BusConnects Dublin Core Bus Corridor Projects

Corridor 1 – Clongriffin to City Centre

Emerging Preferred Route – Public Consultation Report 2018/2019

Section 1: Clongriffin DART Station

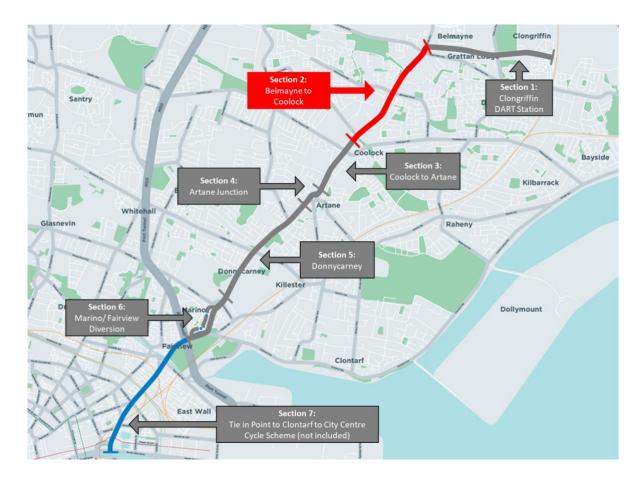
The provision of cycle facilities should be implemented to encourage mode share.

Absolutely no provision for cyclists here.

Main street/Park Avenue Junction: cycle lane stops, and cyclists are encouraged to use bus lane. At present they mount the footpath and will continue to do so which is not safe.

Box/pocket turns for cyclists should be provided on all sides of the junction.

Cycle lane disappears on this map, provision for parking inside the bus lane and where cyclists will be travelling; Potential hazards.

Right hand turns for vehicles should be removed on minor roads.

MAP 4: Submissions fear that cyclists will cycle through pelican crossings. No cycle facilities.

MAP 5: No cycle facilities.

Section 3: Coolock to Artane

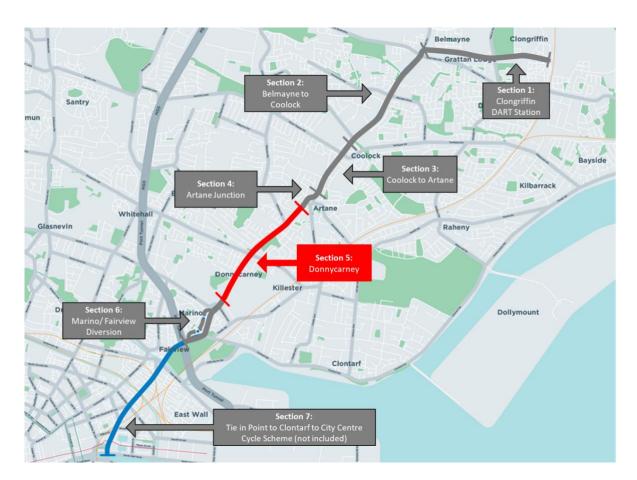
The former Crown Paints' main distribution centre for Ireland is at 1-3 Malahide Road. Existing road layout is designed to physically restrict right-out movements from the site onto Malahide Road. The proposed layout on Map 10 is not as restrictive as the existing layout, vehicles attempting to make this right turn manoeuvre could represent both a risk to traffic safety on Malahide Road, and also result in blocking back of traffic into the site / along Malahide Road. The site entrance should provide for Heavy Goods Vehicles as the future of this warehouse is unknown.

Need to provide a continuous cycle lane here.

Junction should be redesigned to better provide for cyclists with segregated cycle facilities. Access to Mount Dillon Court from Malahide Road is not currently possible

Cycle lanes should cross side streets and minor roads via a raised table.

Danieli Road is currently exit only, but is proposed 2 way?
